RE: LOCI 17-001, Hilcorp Alaska, LLC, Ninilchik Unit, Pearl Pad, Expansion and New Wells Unit Plan of Operations Amendment Decision.

HILCORP ALASKA, LLC PEARL PAD EXPANSION

PEARL PAD EXPANSION

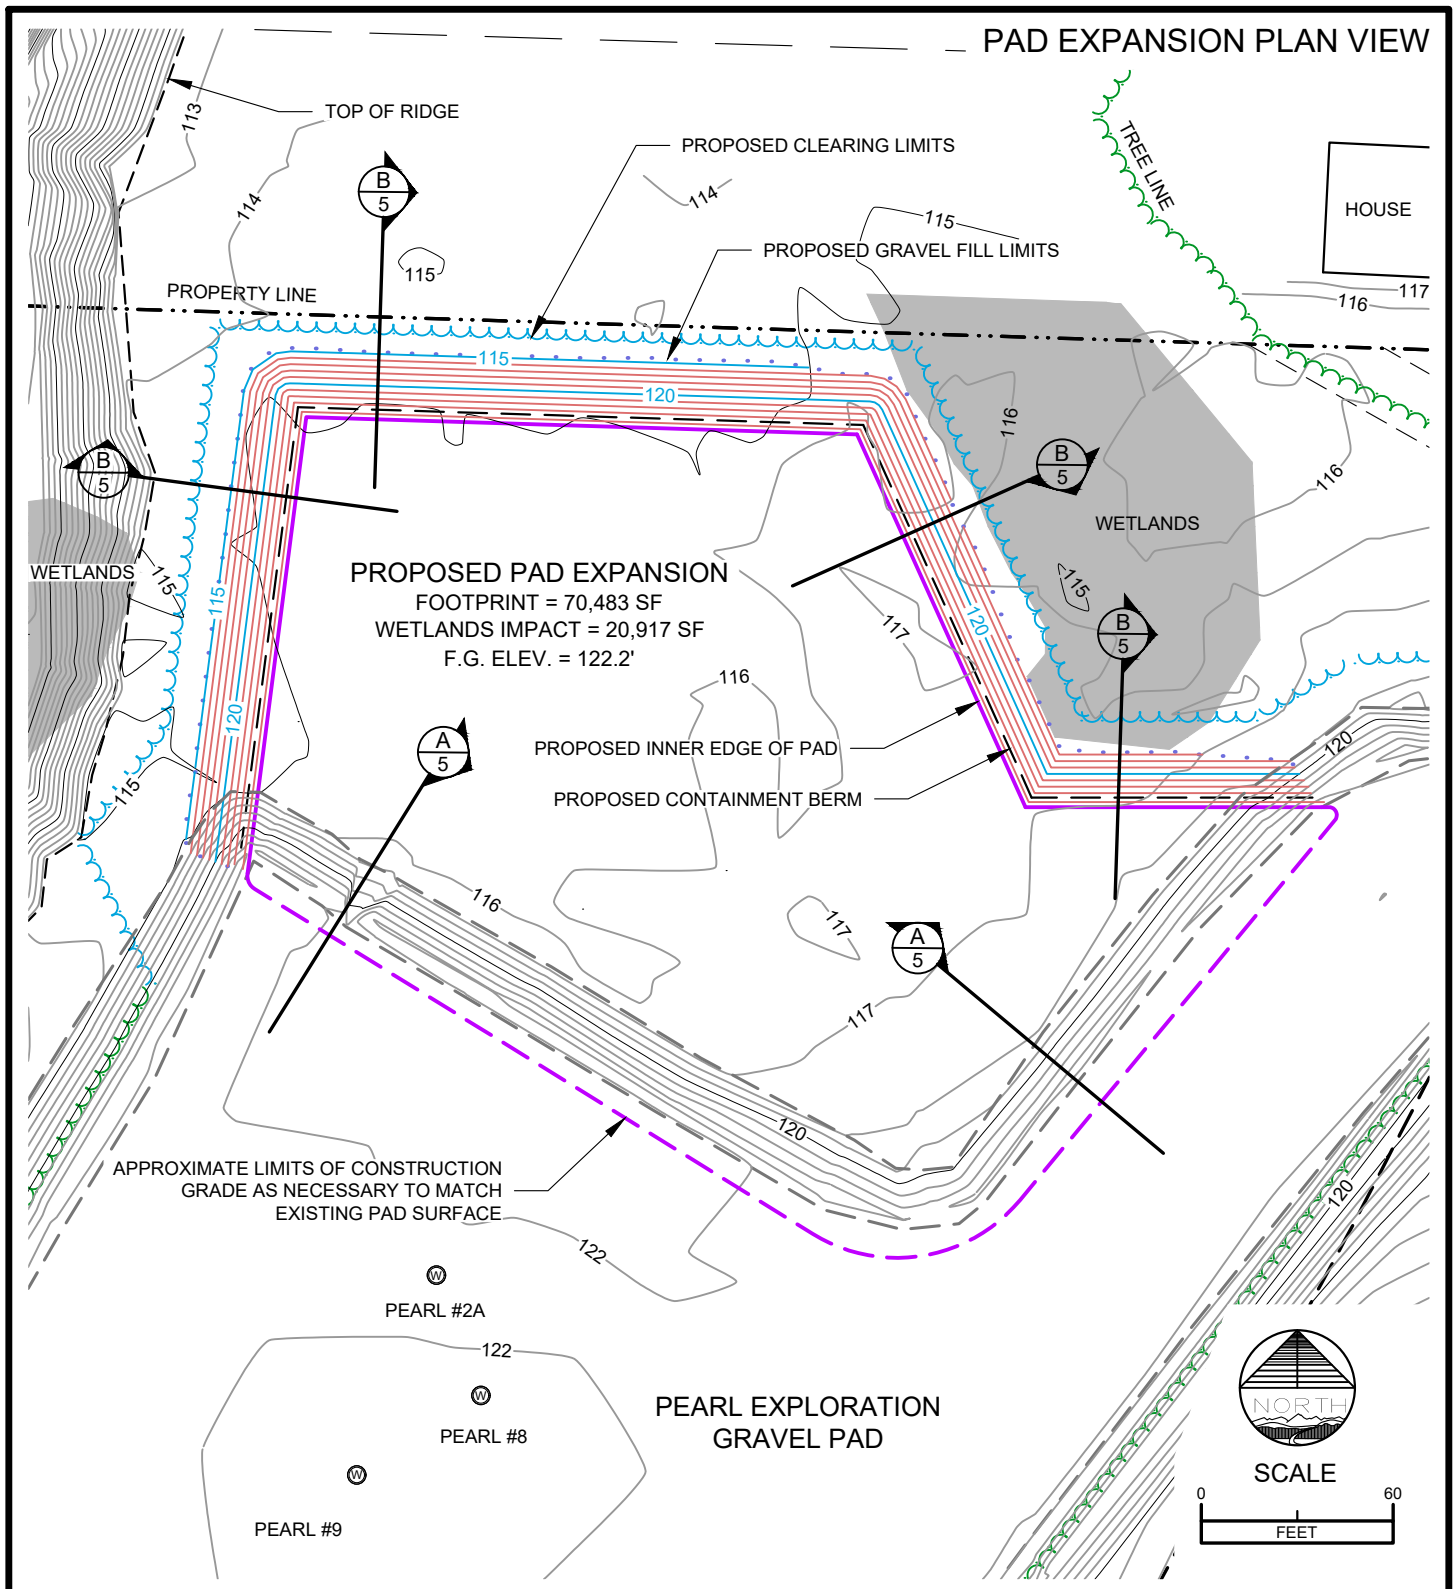
During the adjudication process concerns of potential impacts to the adjacent coastal bluff have been articulated. In addition to the project specific monitoring stipulation described in the decision document, the Division requested that a more detailed description of the coastal bluff assessment process be submitted in response to the concerns. Below is the Hilcorp response to the request.

The proposed Pearl Pad expansion was designed by McLane Consulting, Inc. (McLane). During project planning, McLane performed an extensive field topographic survey of the area. This topographic survey was then validated by aerial imagery. The area shaded purple on the attached “Existing Conditions & Demo Plan” exhibit (**Figure 1**) was determined to be stable and vegetated with large trees. In addition, this area includes a lower bench/swale that serves as the drainage for the nearby wetlands and water seeps from the pad area. The limits of the lower bench/swale area are defined by a second bluff edge, depicted by a heavy, dashed red line in the exhibit, which marks the current limits of active erosion. This bluff edge descends steeply to the toe of the bluff/top of beach and is sparsely vegetated.

Historical orthomosaic imagery was also evaluated from the years 1996, 2006, 2011, 2019, and 2021. The review of this data indicated that the top bluff edge in the area adjacent to the pad expansion has been relative stable and vegetated for at least the past 27 years with little to no erosion evident. The lower bluff edge was observed to be actively eroding but is located at least 93 feet from the existing pad and proposed expansion limits. The relative stability of the area adjacent to the pad expansion is also validated by the presence of heavy vegetation and mature trees extending from 90 to 140 feet from the toe of the existing pad and proposed expansion. This vegetation and trees are evident in photos of the area provided.

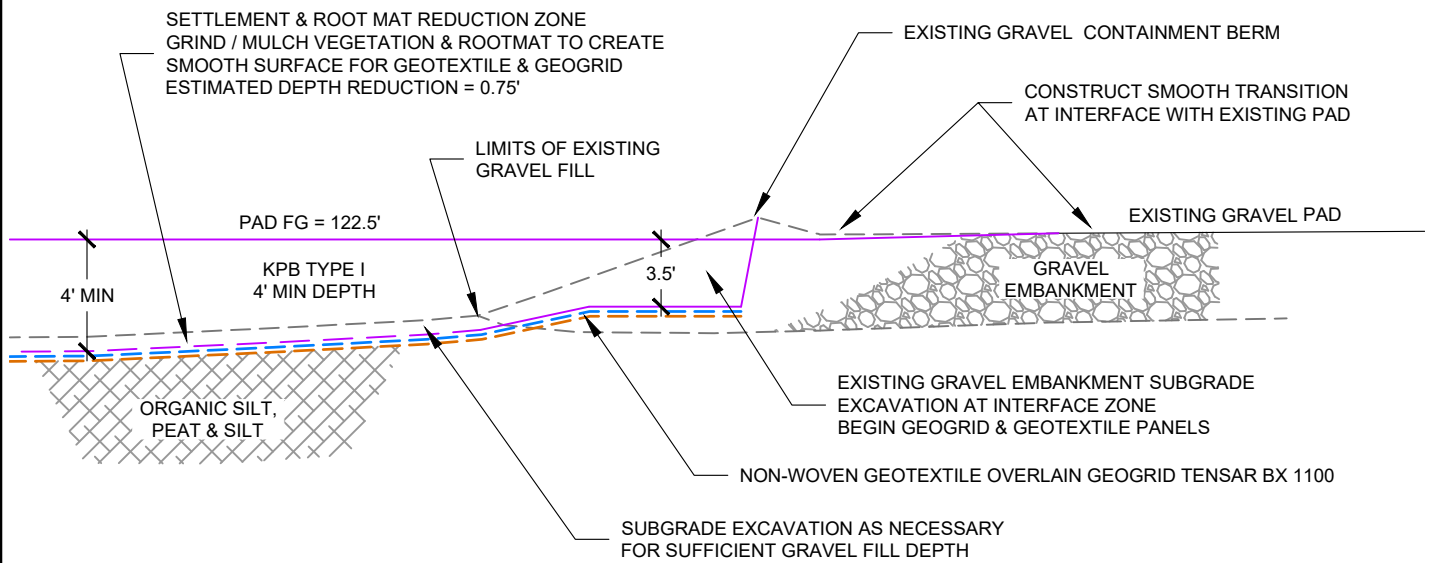
Sheet 4 of 5 of the Pearl Pad Expansion indicates that the edge of the pad is approximately 40’ from a steep bluff. The Bluff slumped significantly in the past. What assurances that drilling as close as 40’ from the top of a steep bluff will maintain integrity of the slope? What effects will moving the intermittent stream to the northern edge of the property have on the slumped bluff and associated erosion.

The physical footprint of the drilling rig does not allow for a wellbore to be placed at the proposed pad edge adjacent to the bluff. The proposed expansion edge is in-line with the existing pad and was selected to reach subsurface resource targets while minimizing the overall pad footprint and impact to wetlands. Hilcorp operators and/or contractors are physically onsite at Pearl Pad at least twice per day. As a standard practice, any evidence of pad instability would be brought to the attention of the Area Operations Manager and Construction Manager as soon as it

is identified. At that time, the potential need for intervention or remedial actions will be evaluated.

The proposed pad expansion will include vegetation removal no closer than 15 feet from the top bluff edge but will not remove the heavy vegetation extending thru the lower bench/swale area to the limit of active erosion. Based on the historical east Cook Inlet bluff erosion rate of approximately 1 foot per year, the lower bluff erosion was not determined to be a significant concern in the near- and medium-term future (approximately 40 years). Furthermore, Hilcorp operators and/or contractors are physically onsite at Pearl Pad at least twice per day. As a standard practice, any evidence of pad instability will be brought to the attention of the area Operations Manager and Construction Manager as soon as identified. At that time, the potential need for intervention or remedial actions will be evaluated.
